Recall Campaign Bulletin

Campaign No. 2020090020, October 2020

SUBJECT: Model GLB-Class vehicles (247 platform)

Catch Mechanism Second Row Seat

Figure 1

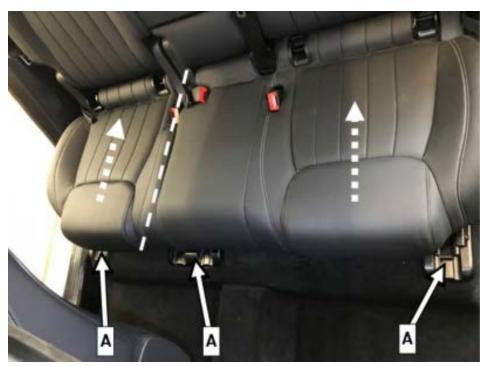
- At the 2nd seat row, the lock may not be correctly engaged within the seat rail.
- i With the work procedure, it will be ensured that the lock engages in parallel on both sides within the seat rail.
- The work procedure must be performed on the left and right seat frame base of the 2nd seat row.
- 1. Actuate adjustment lever for fore/aft adjustment and slide seat frame base **toward rear** all the way to the end stop.
 - The adjustment lever is located at the front under the seat surface.
- 2. Remove covers (A, figure 1).
